HOWARD COUNTY HISTORIC PRESERVATION COMMISSION

September Minutes

Thursday, September 1, 2016; 7:00 p.m.

Figure 10 - Approved facade restoration plan

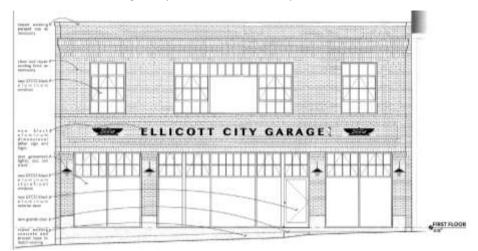
Staff Comments: The change from a metal storefront window to a wood storefront window could be considered appropriate, as wood is a historic building material. As the historic storefront no longer exists, it is unknown what the previous materials were, but given the use of the building and the research done to come up with the new design, it was most likely metal. The application states that flat wood will be used, but the photo examples submitted show existing wood storefront windows with a raised profile and bead to the wood. The transom will be leaded glass, similar to the transom at Taylor's Department Store.

Staff does not have a clear understanding of what the proposed change will look like in the end. A lack of detail between the Commission and previous applicant is why the altered window looked different in the end than originally proposed. One of the example photos submitted shows the storefront window at 8090 Main Street. The windows at 8090 Main Street have a wide wood mullion (the vertical element separating the glass), which would not match the approved design on this new storefront, nor would it be appropriate. The metal window was going to be very slim and Staff is concerned that wood would not replicate this design. Staff requires further information on the size of the mullions.

Staff Recommendation: Staff recommends Denial of wood windows without confirmation that the wood will mimic the approved metal design and dimensions.
